BOSTON EDISON COMPANY
800 BOYLSTON STREET
BOSTON, MASSACHUSETTS 02199

BECO Letter No. 83-181

Subject: NUREG 0612: Control of Heavy Loads

ENCLOSURE I
RESPONSES TO FRANKLIN RESEARCH CENTER
DRAFT TER - C5257-109 DATED FEBRUARY 12, 1982

FIGURE 1

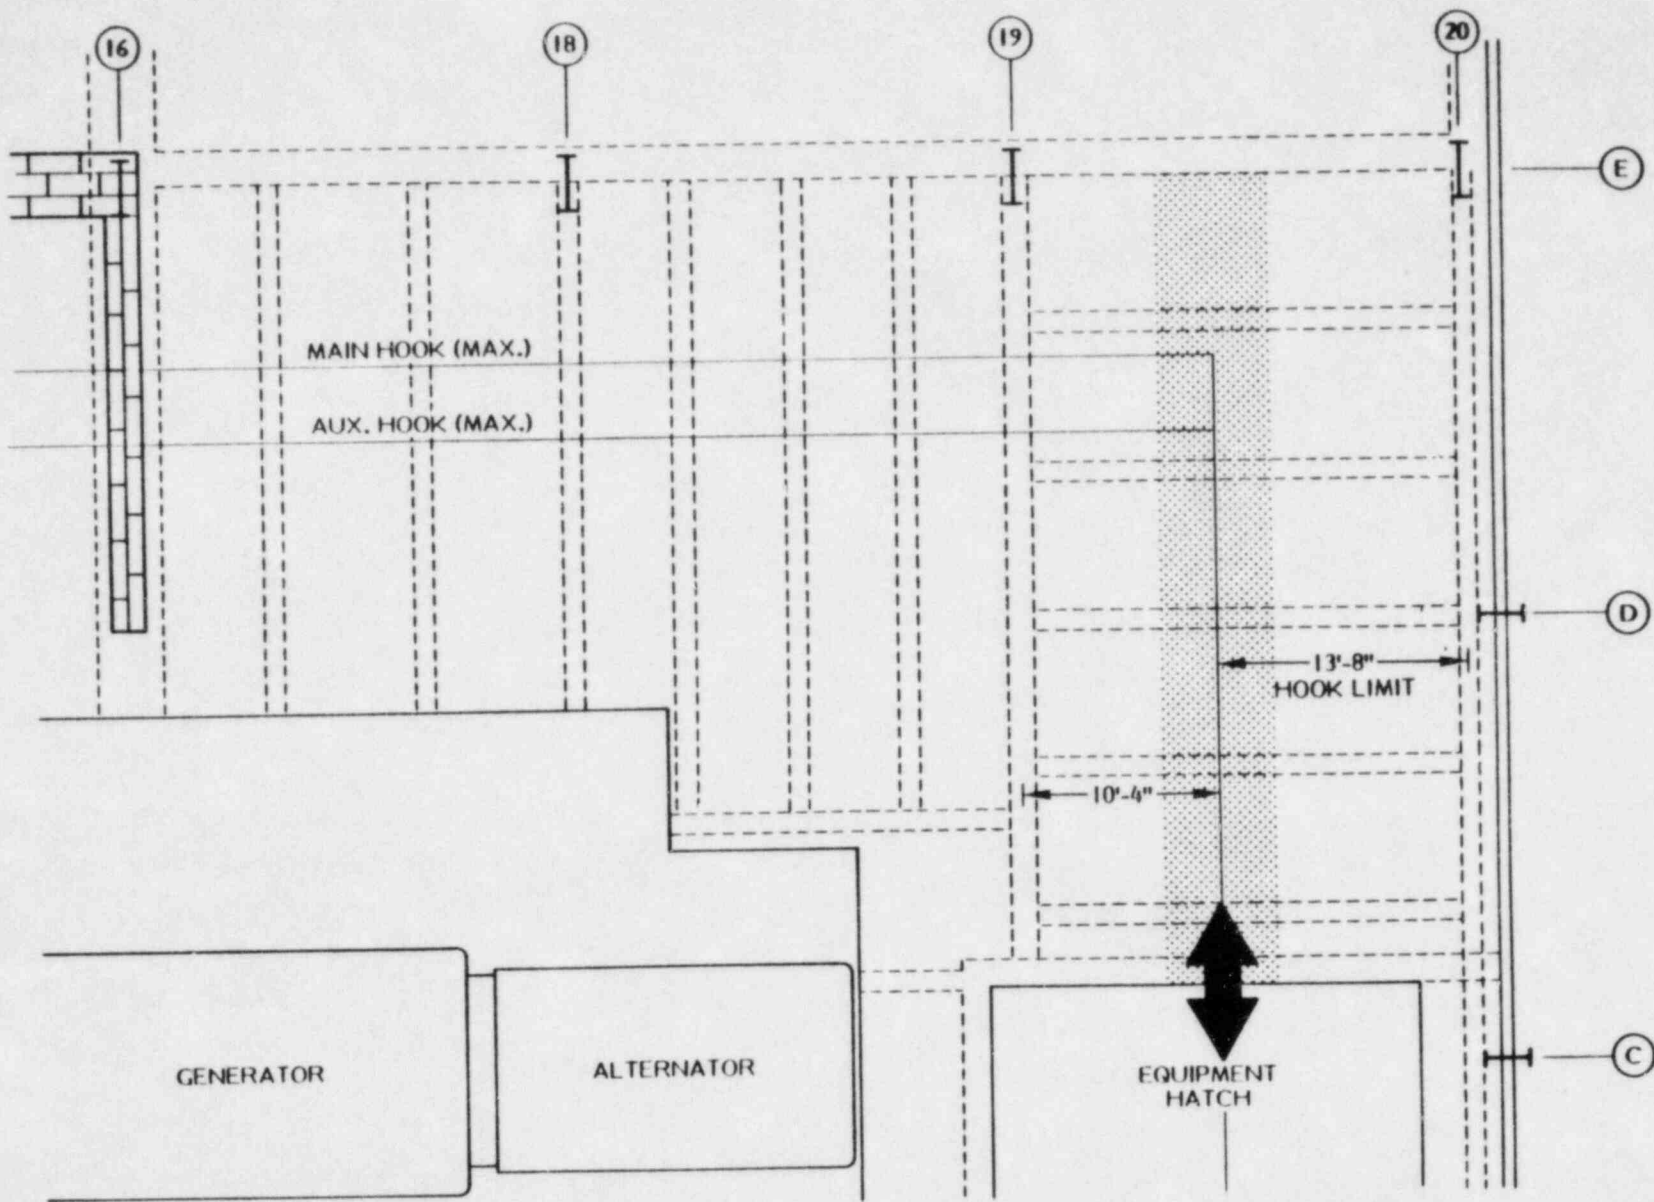
As indicated in Table 2, there are two distinct load handling areas in terms of potential load drop consequences associated with the Turbine Building Crane. These are Load Impact Regions 16 and 17 (see Figures 10 and 11 in Enclosure 2 to this submittal). Load drops in Region 16 will not affect the ability of safe shutdown systems to perform their safety functions.

On this basis, and conservative structural analyses of the Region 17 floor area, load handling procedures will impose two levels of administrative control. As indicated in Enclosure 2, more rigorous structural analyses are being performed that may result in refinement of the specifics of these administrative restrictions. The first level of administrative control is illustrated in Figure 1 and involves defining an exclusion area over which only certain heavy loads can be carried. All other heavy loads will be handled by the Turbine Building Crane in Region 16 outside of this exclusion area.

FIGURE 2
 INTERIM SAFE LOAD PATH
 FEEDWATER HEATER AND REACTOR FEED PUMP COMPONENTS
 TURBINE BUILDING 51' EL.

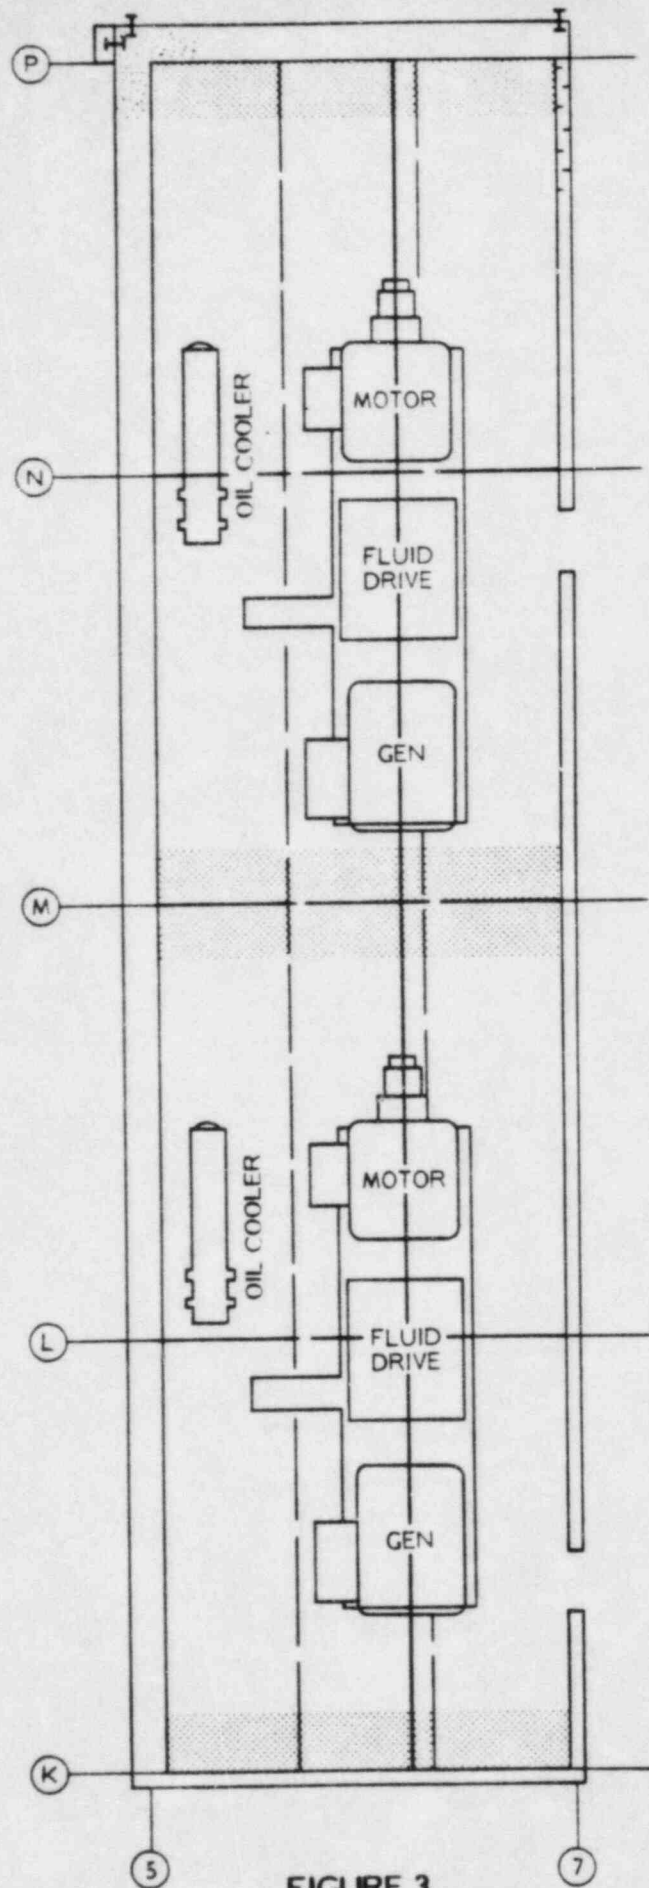
The second level of administrative control involves defining specific safe load paths for certain limiting loads within Region 17. The loads involved are listed in Table 2. The safe load paths are illustrated in Figure 2. In addition to safe load paths, procedures will specify limits on carry heights within this region.

FIGURE 10
LOAD IMPACT REGION 16
TURBINE BUILDING PLAN EL. 51'-0"

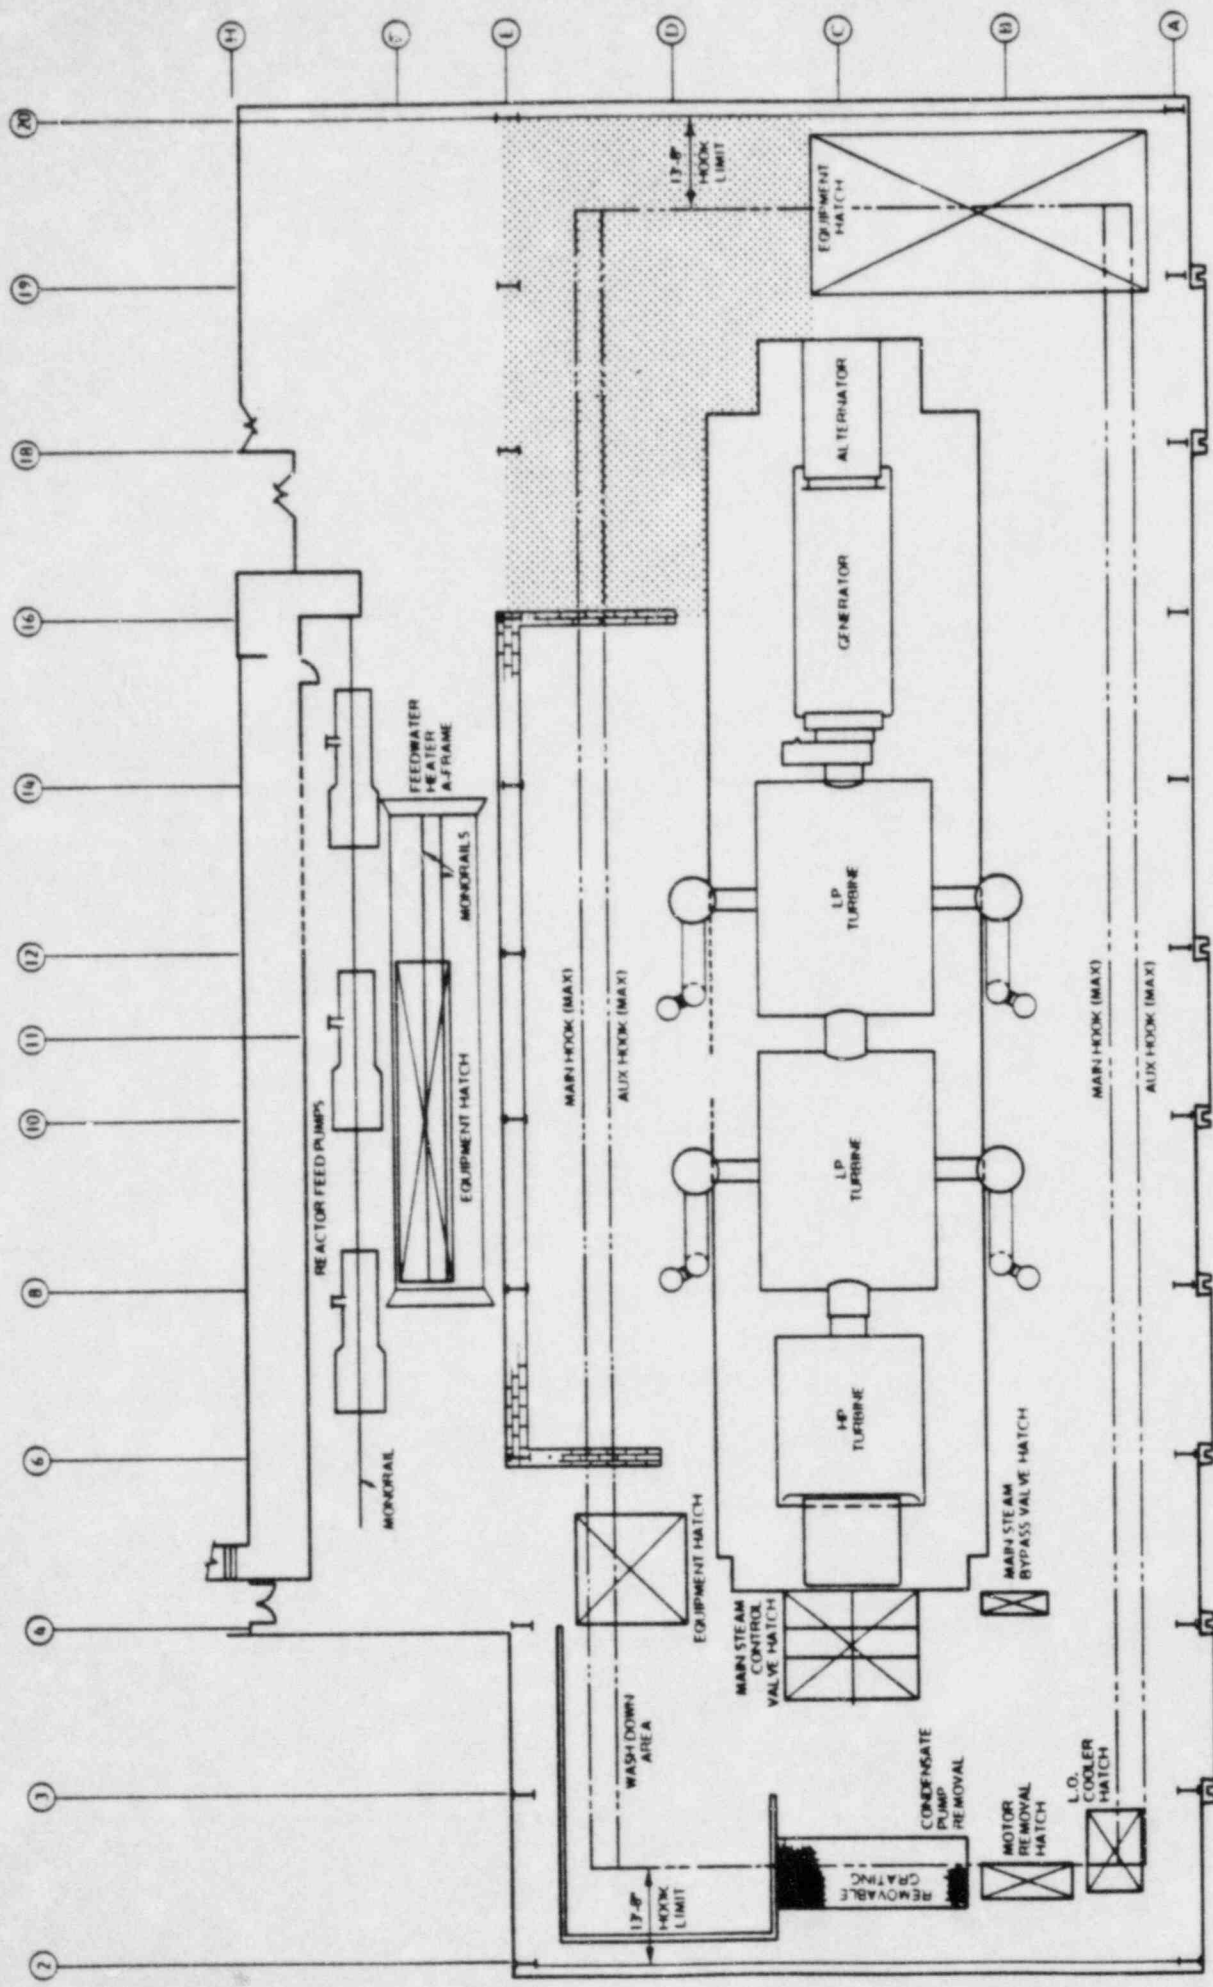
The elevations below the 51' el. turbine deck in Region 17 (Figure 11) contain electrical equipment associated with the operation of both trains of safe shutdown system components. This equipment is separated vertically (Train A at the 37' el. and Train B at the 23' el.). Conservative structural analyses were performed of this area to determine if damage from postulated heavy load drops could be limited to the 37' el. immediately below the 51' el. slab. This involves demonstrating no perforation of the slab or overall collapse of the floor system.
